Harnett County Department of Public Health Improvement Permit

RE: Flow Reduction Certification and As-built

Mason Pointe Lot 57
186 Rawls Meadow Lane, Fuquay Varina, Harnett County, North Carolina
Project #:2031

Subject: 186 Rawls Meadow Lane, Mason Pointe Subdivision Lot 57
LHD Request for Review – Session Laws 2013-413 and 2014-120
Project Number: 2020-35

Harnett County Department of Public Health Site Sketch

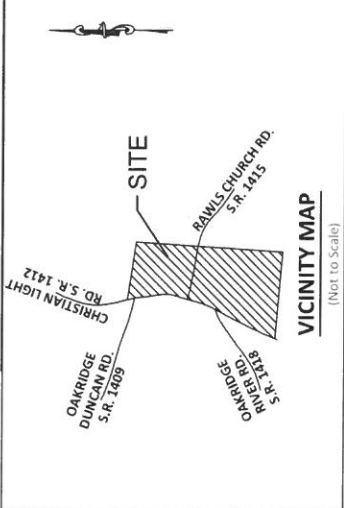
* CUTSHEETS OF SEPTIC *
TANKS AND PUMP TANKS
REQUIRED FROM
MANUFACTURER

- 1) ABANDON EXT 1000gal concrete SEPTIC TANK, REPLACE W/ 1250gal CONCRETE SEPTIC TANK
- 2) ABANDON EXT 1000gal concrete SEPTIC TANK, REPLACE W/ 1250gal PLASTIC SEPTIC TANK [NO TANK THICKNESS]
- 3) ADD 1000gal concrete or plastic SEPTIC TANK TO EXT concrete TANK TO MEET 1250+ gal CAPACITY

SPECIFIED LOWER-FLOW FIXTURES, LOW FLOW TECHNOLOGIES, OR REPLACEMENT W/ EQUAL OR LESS FLOW RATES ARE TO REMAIN IN USE FOR THE LIFE OF THE SEPTIC SYSTEM
